SUBJECT: **ADDENDUM # 2**

PROJECT TITLE: West Campus Development – Phase 2
Norwalk Community College
Norwalk, Connecticut

PROJECT NO.: **BI-CTC-406**

BID OPENING	**1:00 P.M.**	**August 12, 2009**
ADDENDUM NUMBER TWO	**DATE OF ADDENDUM**	**July 30, 2009**

SK-A8.03-A

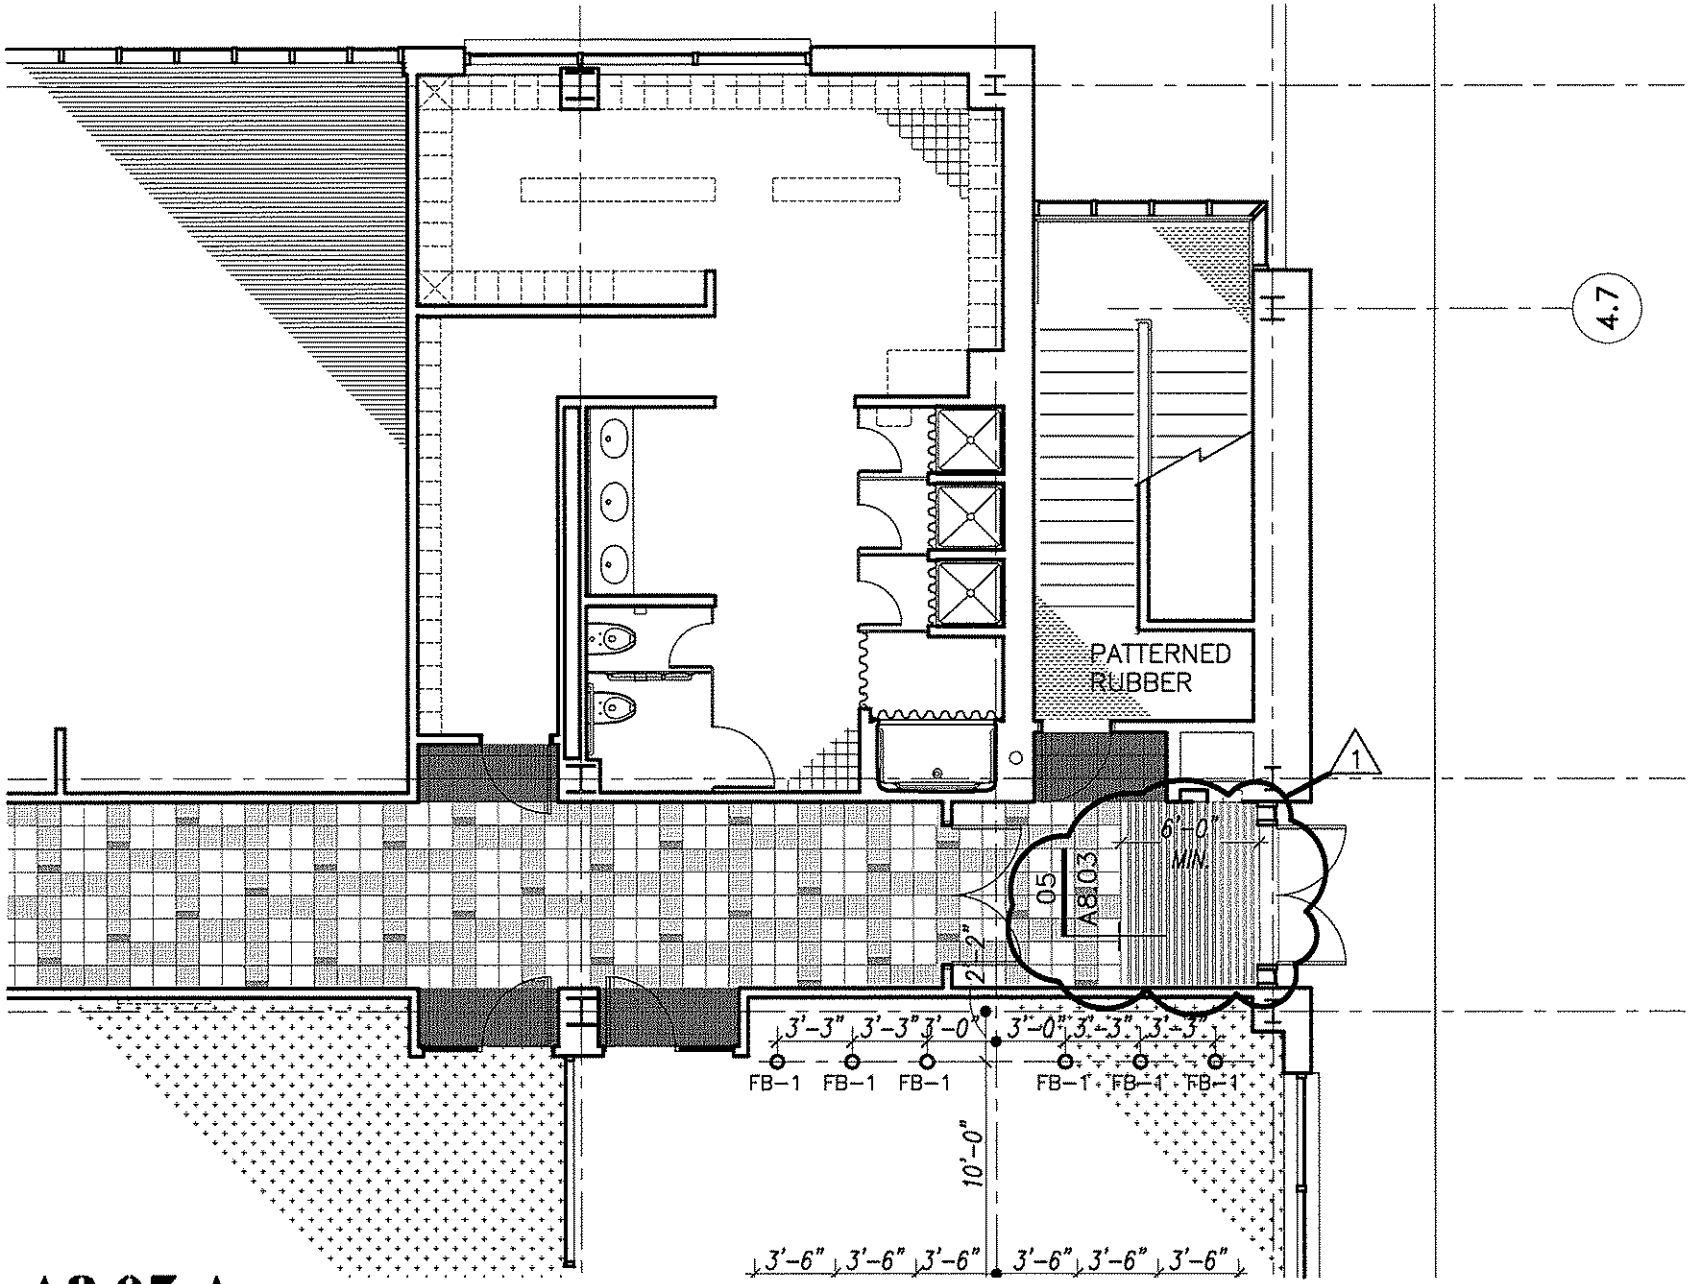
1. SK-A2.00-A "Ground Floor Addition Plan"
2. SK-A7.40-A "Type M Plaque Sign"
3. SK-A8.03-A "Ground Floor Flooring Pattern-New Building"
4. SK-M3.06-A "Gas Train Piping Diagram"
5. SK-M3.06-B "#2 Oil Piping Diagram"
